BOROUGH OF OCEANPORT PLANNING BOARD

REGULAR MEETING • AGENDA

Review No. 3

62 Manitto Place - Block 52, Lot 2
Borough of Oceanport, Monmouth County, New Jersey
Colliers Engineering & Design Project No.: OPP-0386

1 GRADING PLAN
 3/16" = 1'-0"

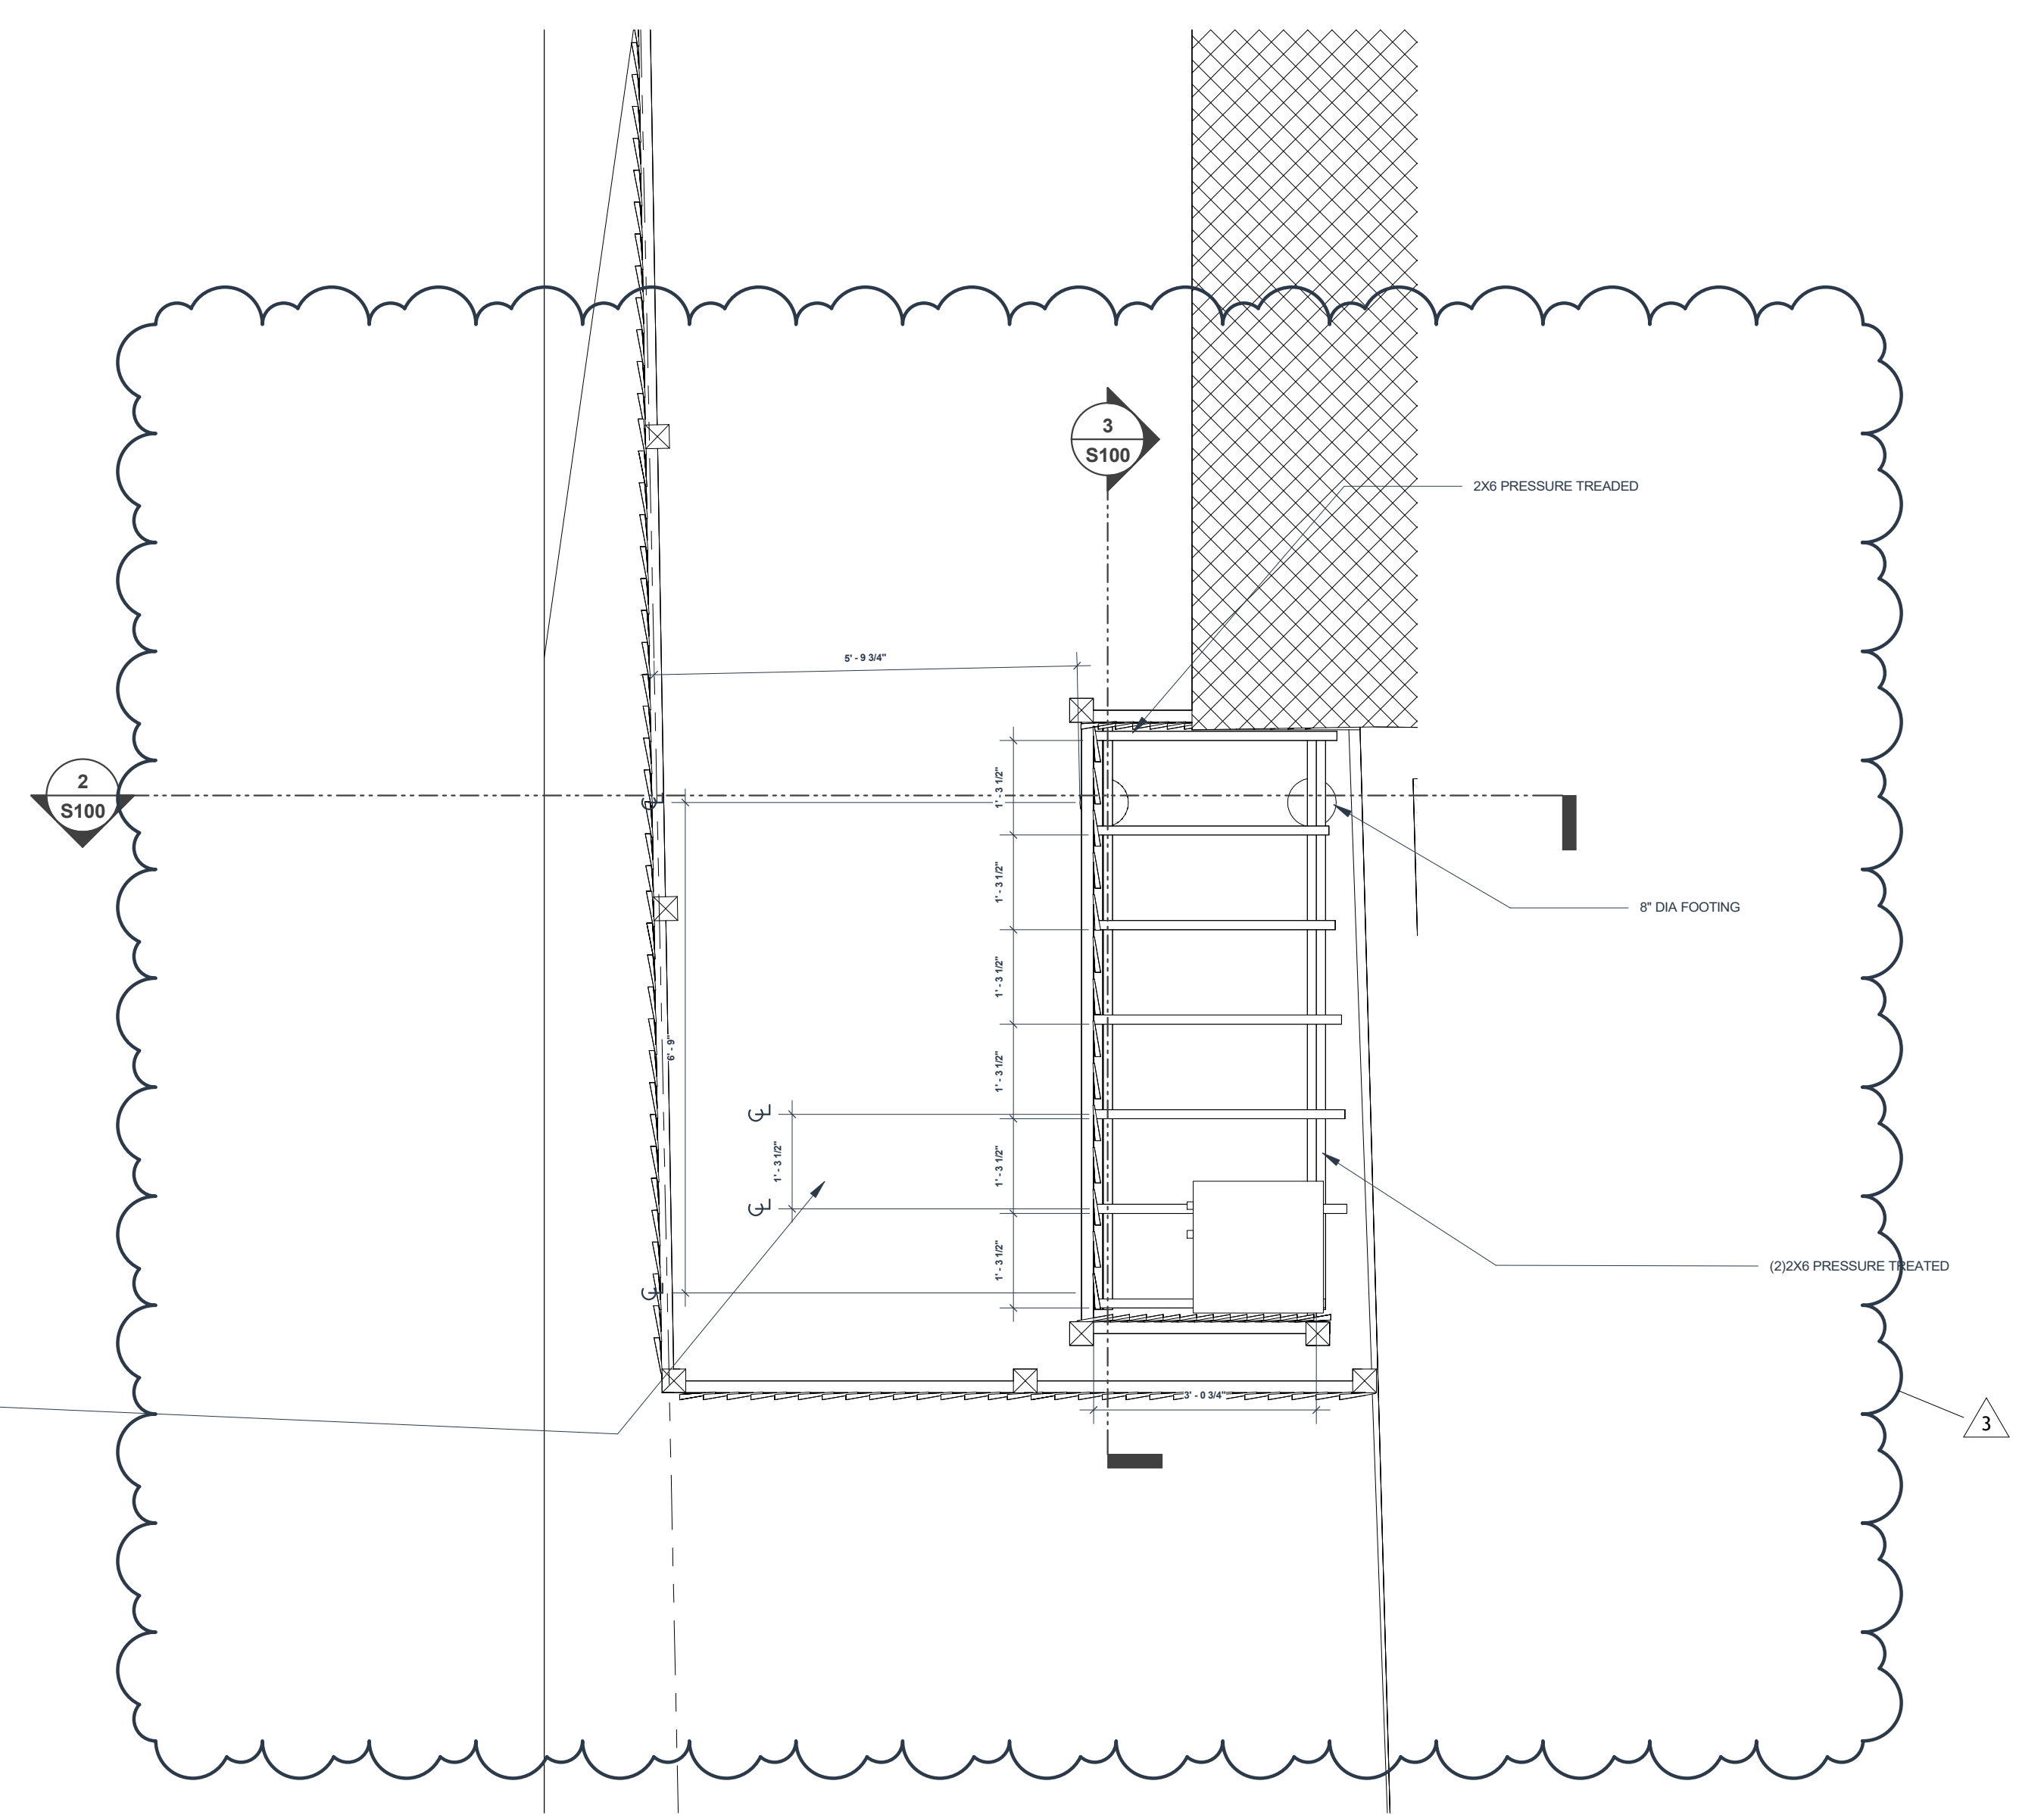
1. A signed and sealed copy of the survey shall be provided to the Planning Board Clerk.
2. The applicant has increased the side yard setback to the equipment platform from 1.8 feet to 5.8 feet.
3. Spot grades are needed for the patio at the back of the dwelling to assure positive slope to the trench drain.
